ADDENDUM NO. 1

**RE: Item #1, June 5, 2024 Letting - BRO-B 8034(34), PCN 0851, Hutchinson County - Structure
(102' Continuous Concrete Bridge) & Approach Grading**

| | BRO-B 8034(34) | 21 | 110 |

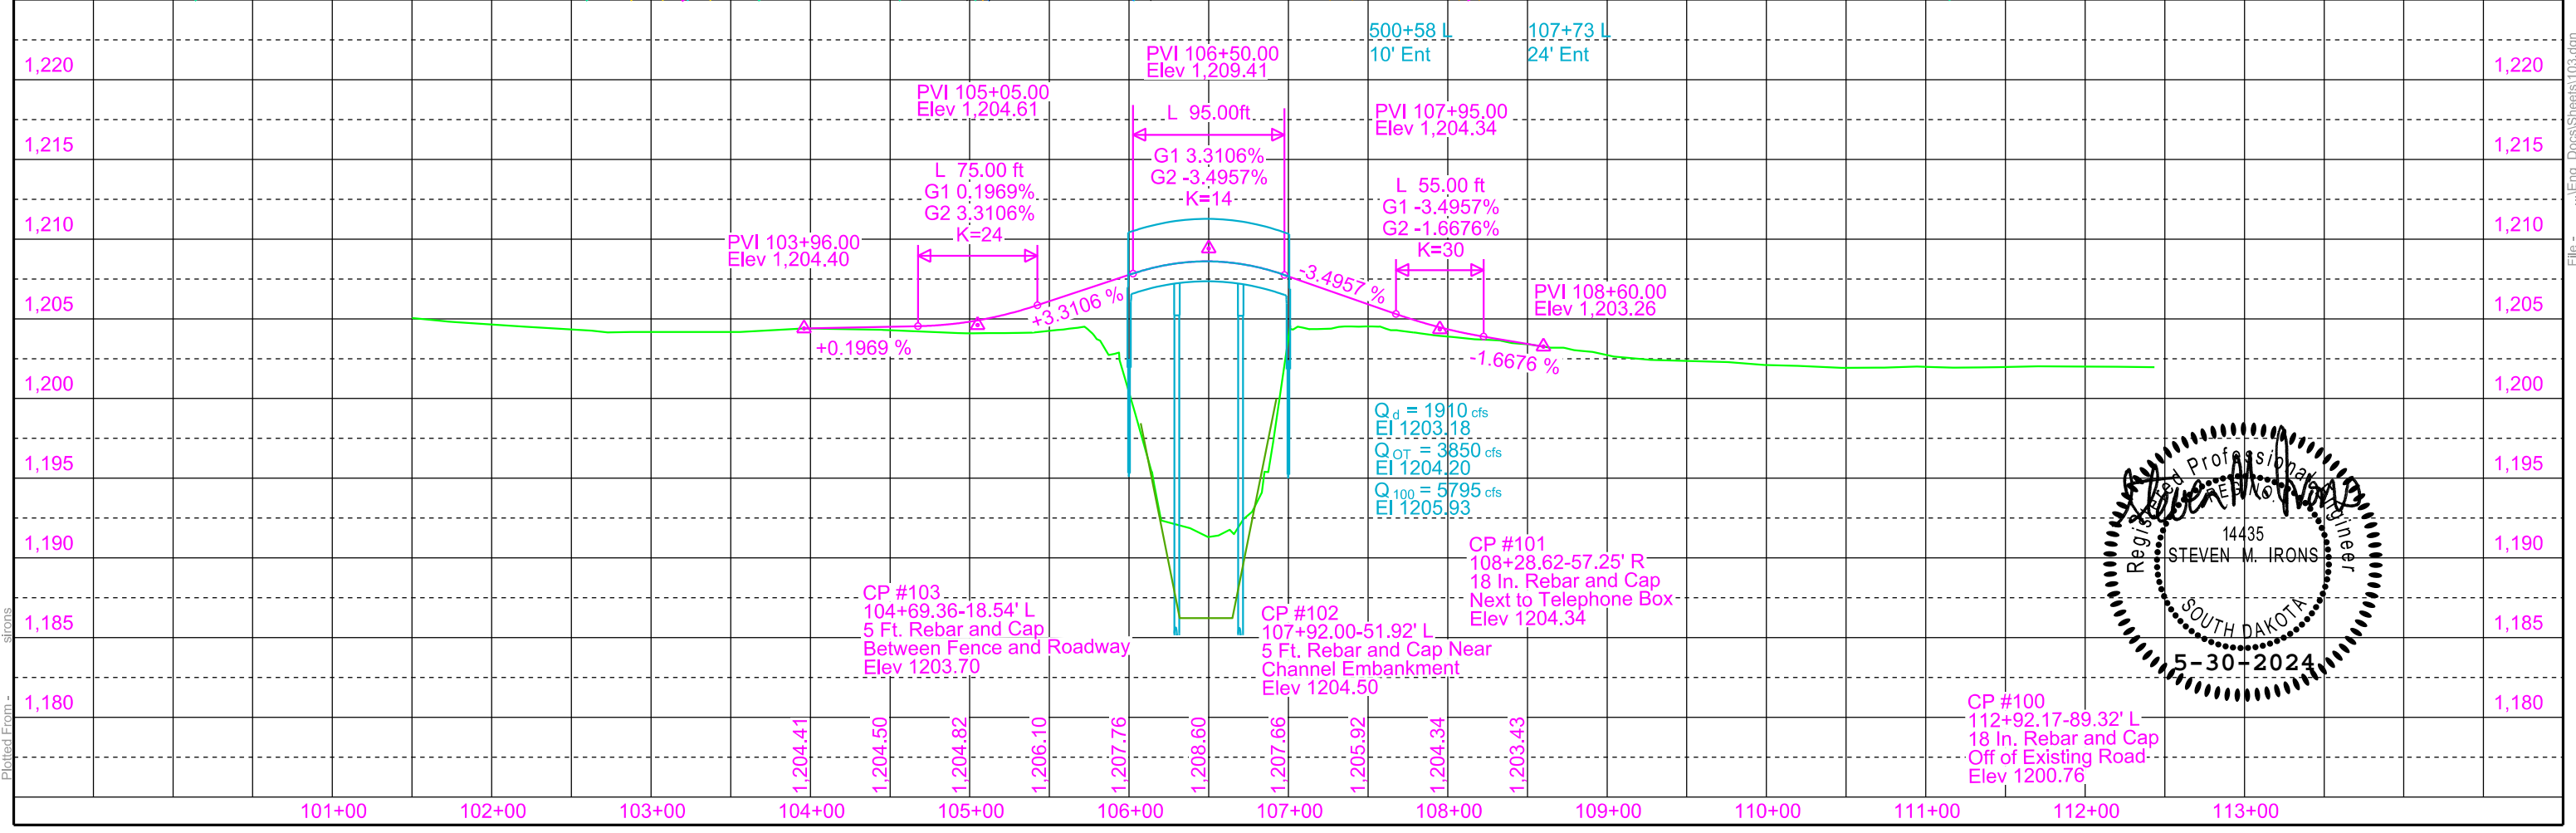
Sheet 21: Orange Plastic Safety Fence was added.

STA. 103+96.00
103+00 L (---)
Begin Orange Plastic Safety Fence
106+37 L
End Orange Plastic Safety Fence (500')
